ADDENDUM NO. 1 TO THE
SPECIFICATIONS
AND
CONTRACT DOCUMENTS
FOR THE
TOWANDA MUNICIPAL AUTHORITY WASTEWATER TREATMENT
PLANT UPGRADES
PROJECT NO. 22-6006
TOWANDA MUNICIPAL AUTHORITY
TOWANDA BOROUGH, BRADFORD COUNTY, PENNSYLVANIA

ADDENDUM NO. 1

TOWANDA MUNICIPAL AUTHORITY WASTEWATER TREATMENT PLANT UPGRADES APRIL 4, 2025

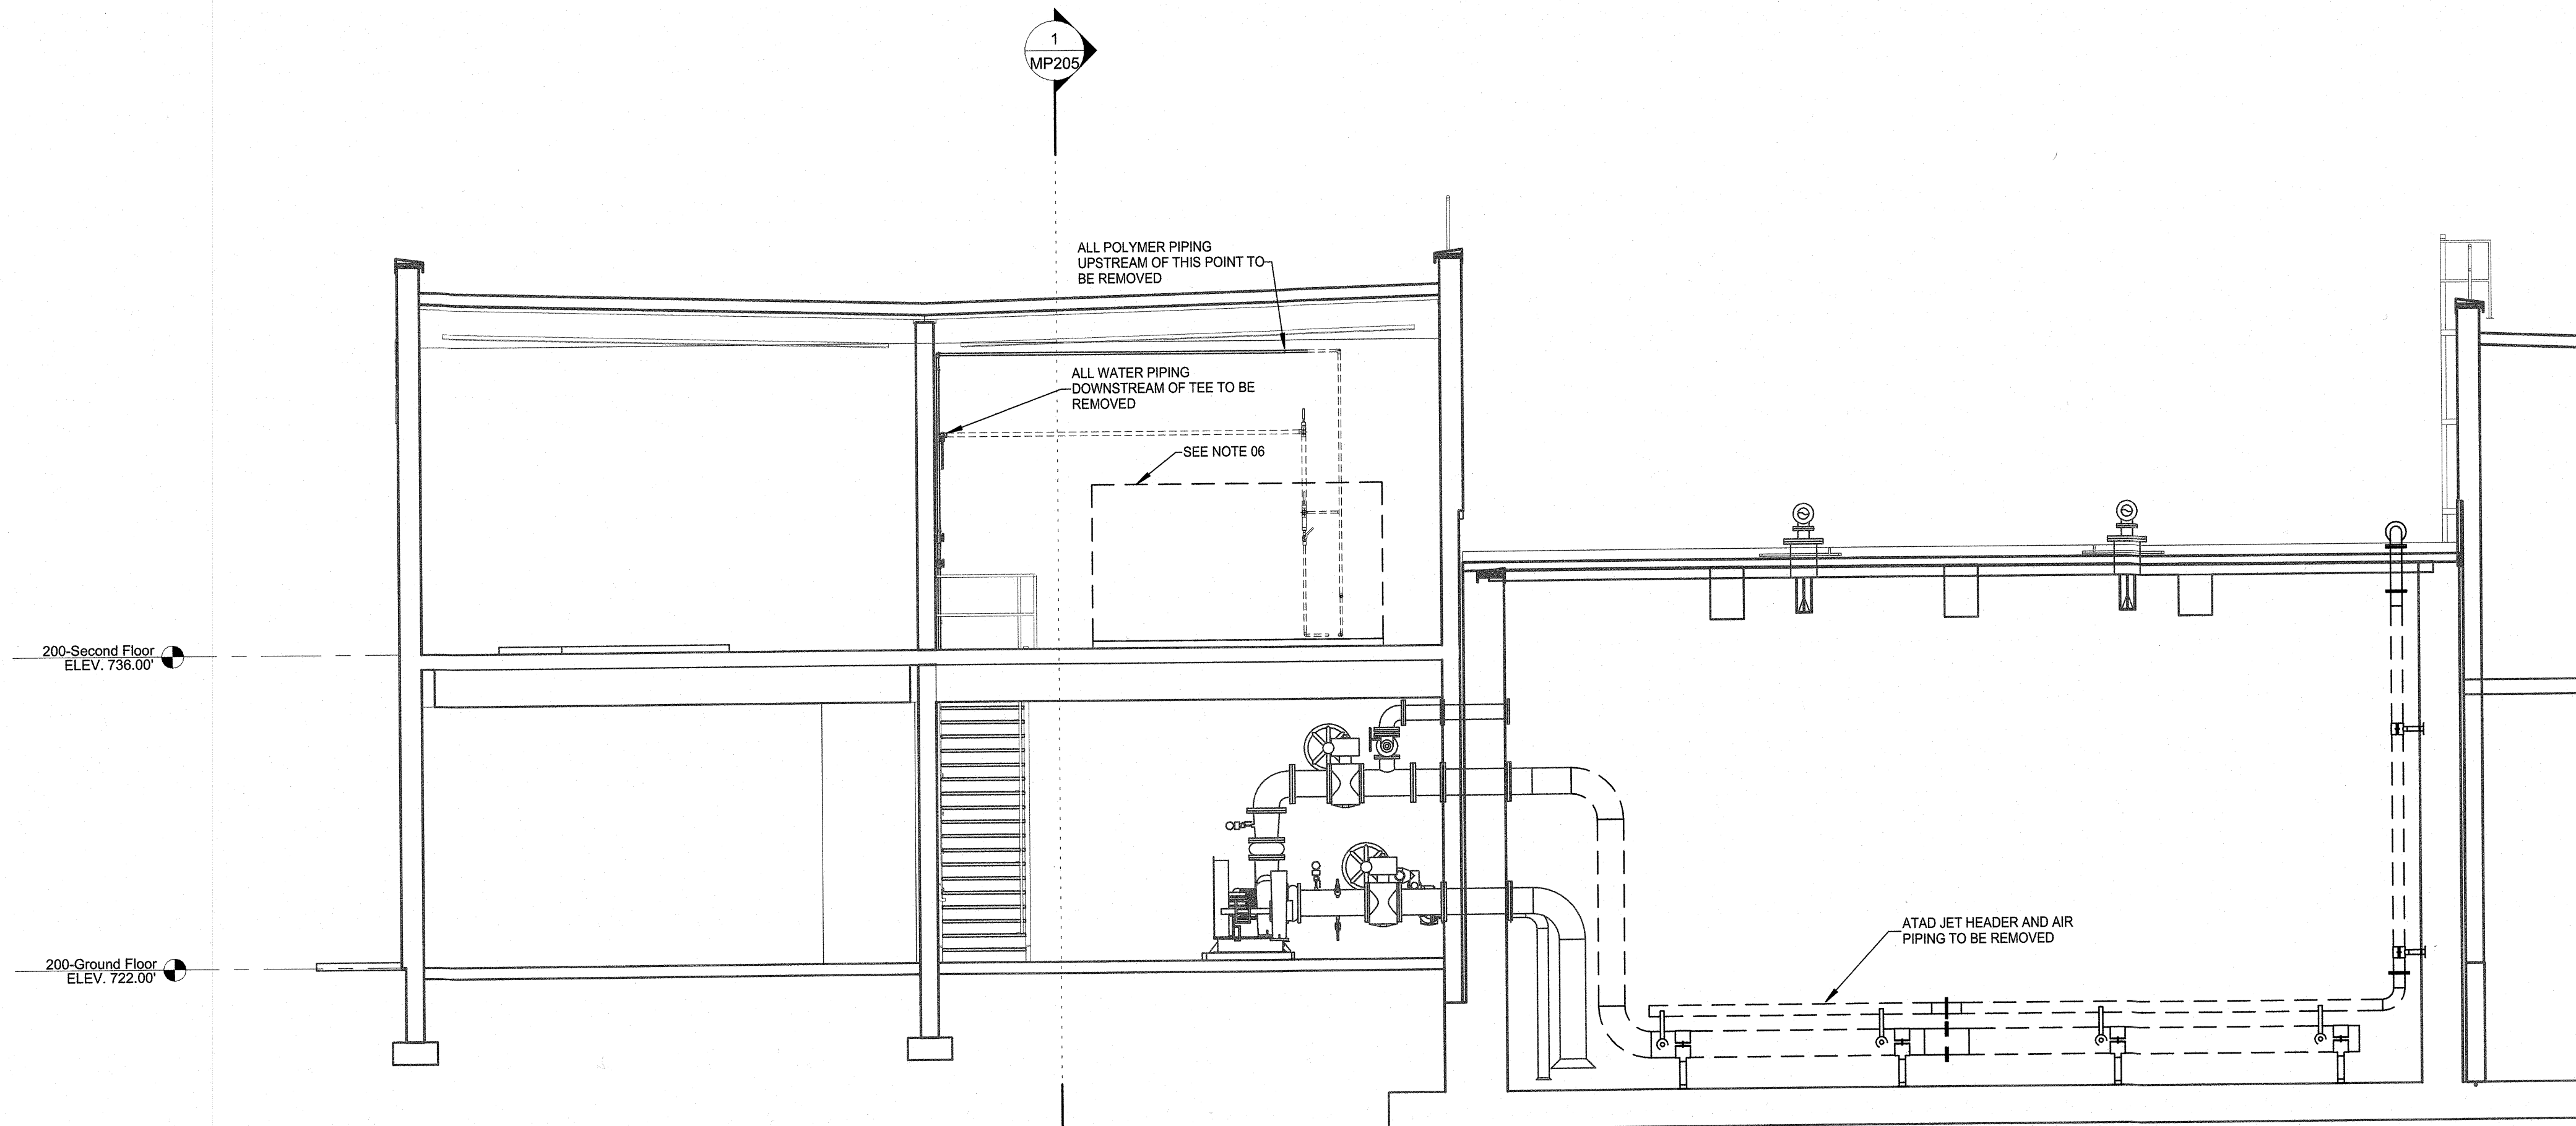
3. Plan Sheet MP203

A revised copy of this plan sheet has been attached to this addendum. The plan sheet now depicts the configuration of the ATAD jet header and air piping above the ATAD tank in a manner which is consistent with the revised Specification Section 467322.
